March 28 2016

TO: Department of Energy  
U.S. Department of Energy  
Office of Nuclear Energy, Response to IPC  
1000 Independence Ave SW.  
Washington, DC 20585  
consentbasedsiting@hq.doe.gov

RE: Response to IPC – DOE’s radioactive spent fuel storage plan is designed to leak

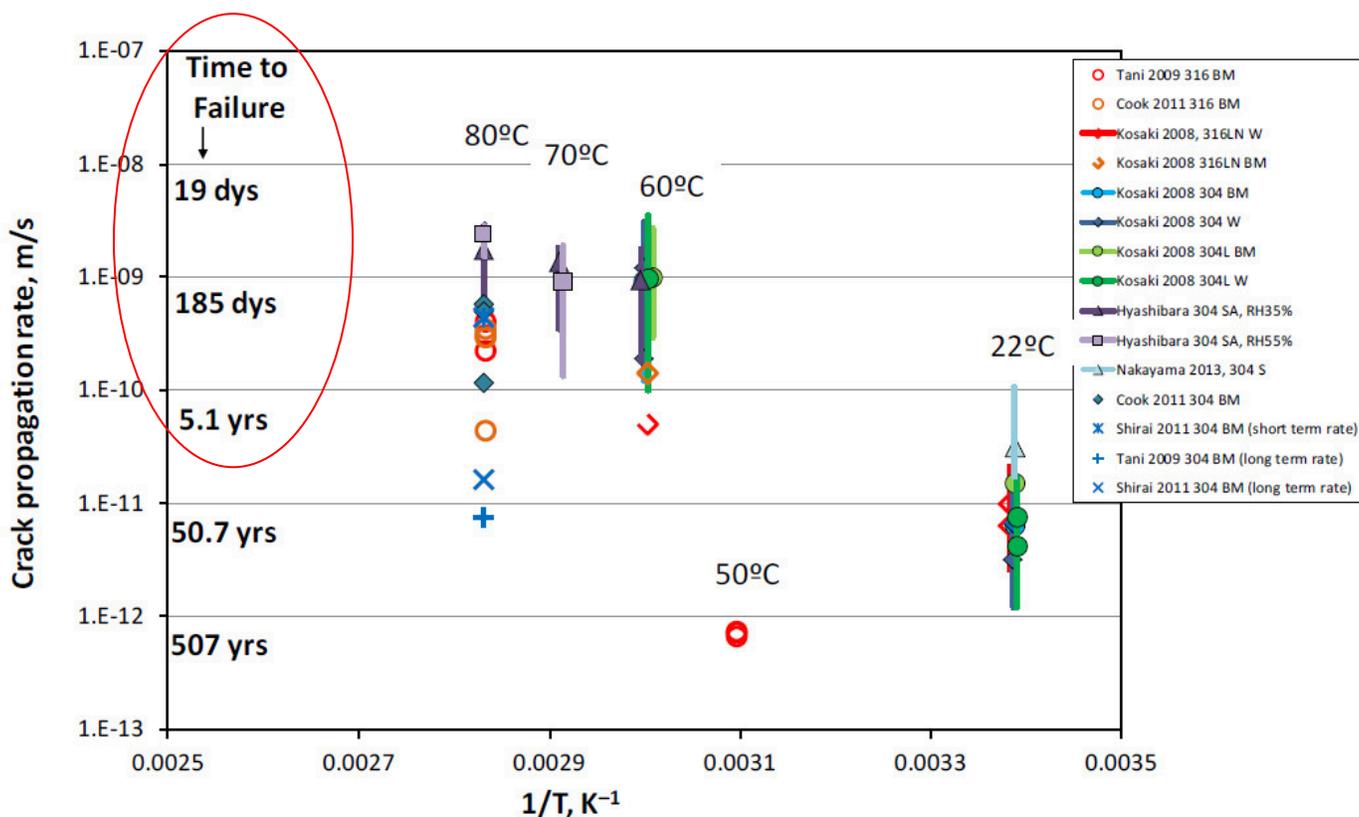
**DOE pilot project is designed to fail and leak radiation:** The proposed DOE irradiated spent fuel nuclear waste storage plan is designed to fail. It proposes transporting and storing existing thin-walled stainless steel canisters (1/2” to 5/8” thick) that cannot be inspected, repaired, maintained, have no early warning system prior to a radiation leak, can corrode and crack, and can start leaking millions of curies of radiation after 20 years of storage, possibly sooner. A 2015 Sandia Lab report shows that once cracks start in hotter thin-walled stainless steel canisters, they can grow through the wall of the canister in less than 5 years (Attachment - Sandia Chart).

Thin-walled stainless steel U.S. irradiated spent fuel storage canisters at higher temperatures will have faster crack growth rate. The Sandia Chart below shows higher temperatures can cause canisters to penetrate the wall in less than 5 years. This chart assumes canister wall is 0.625” (5/8”) thick. The majority of the U.S. canisters are only 0.50” (1/2”) thick. It is unknown when a crack will start, but these canisters are subject to corrosion and cracking from environmental conditions such as chloride salts, air pollution (sulfides), pitting, and microscopic scratches. The report states that canisters such as those at Diablo Canyon have temperatures in these heat ranges.
